NSW EPA  
**The Next Generation (NSW)  
Energy from Waste Facility,  
Eastern Creek EIS**  
Merit Review

Issue | 3 August 2015

Figure 3.1: Breakdown of waste feedstock.

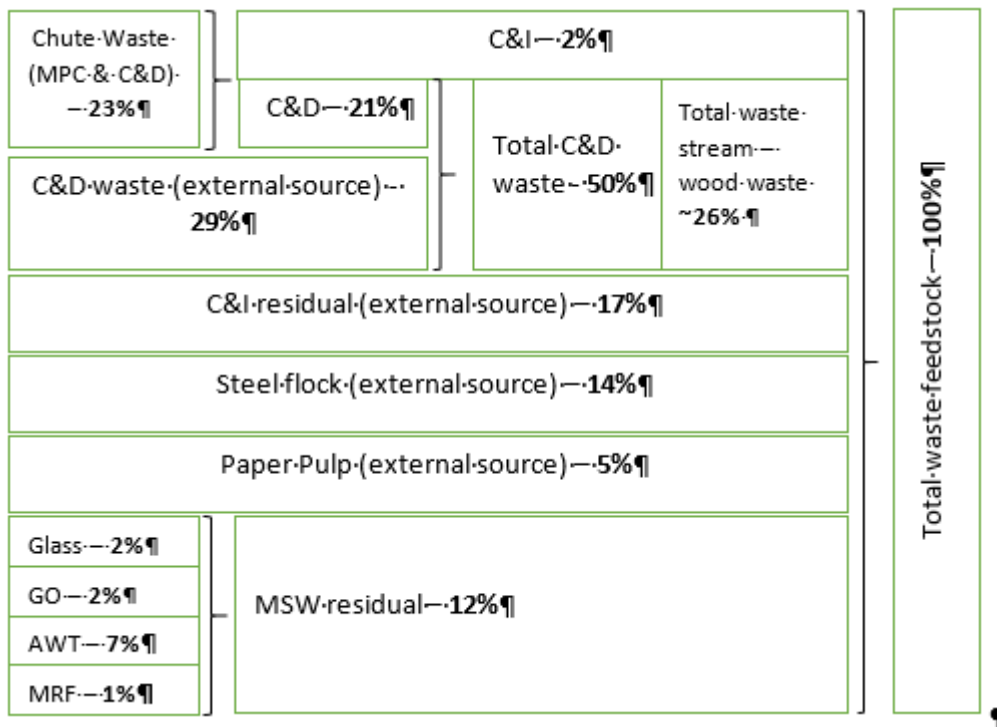
Arup consider that insufficient details have been provided in the EIS to allow a full comparison and assessment of the TNG proposed feedstock in the ratios suggested to the facilities listed in Table 4 – Section 3.5 of the EIS.
